PJM Interconnection, L.L.C.  
2750 Monroe Blvd.  
Audubon, PA 19403-2497

February 14, 2019

*Re: PJM Interconnection L.L.C., Docket Nos. ER19-105-000 and ER19-105-001  
Responses to Deficiency Letter re: Periodic Review of Variable Resource Requirement  
Curve Shape and Key Parameters*

**Figure 1.**<sup>17</sup>

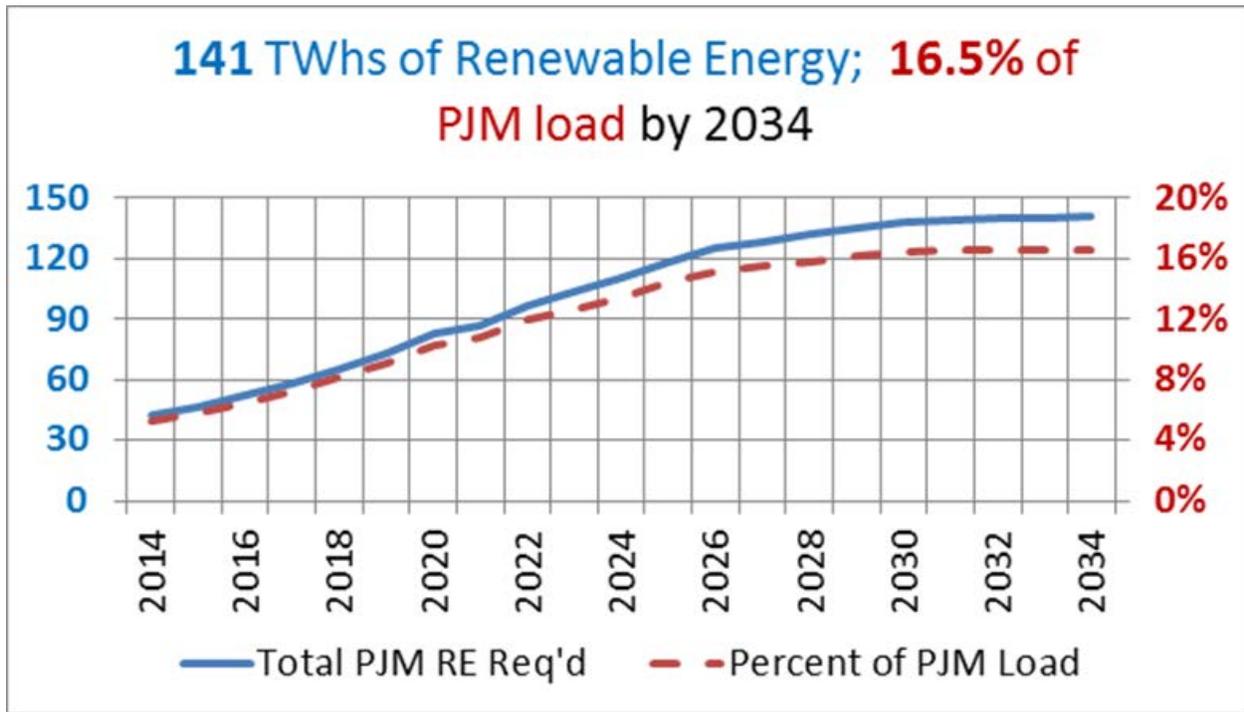
PJM anticipates that the modularity, flexibility, and economics of the GE 7HA turbine is expected to become increasingly important with the growth of intermittent resources. As shown in Figure 1 below, renewable resources are expected to generate approximately 30 more terawatt hours in 2022 than they do today due to state policies (increasing from 8% of load to 12% of load). Wind resources alone are expected to increase by approximately 9,000 MW by 2022. The average capacity factor of combustion turbines in PJM has increased 6.5 percent in the past decade, coinciding with the increase in the percentage of PJM generation from intermittent resources from 3.6% to 5.9%. The H-frame combustion turbine specifications are better suited to respond to the increase in intermittent resources in PJM markets than the smaller slower responding F-frame or for that matter, banks of costlier reciprocating engines because of their superior economics.
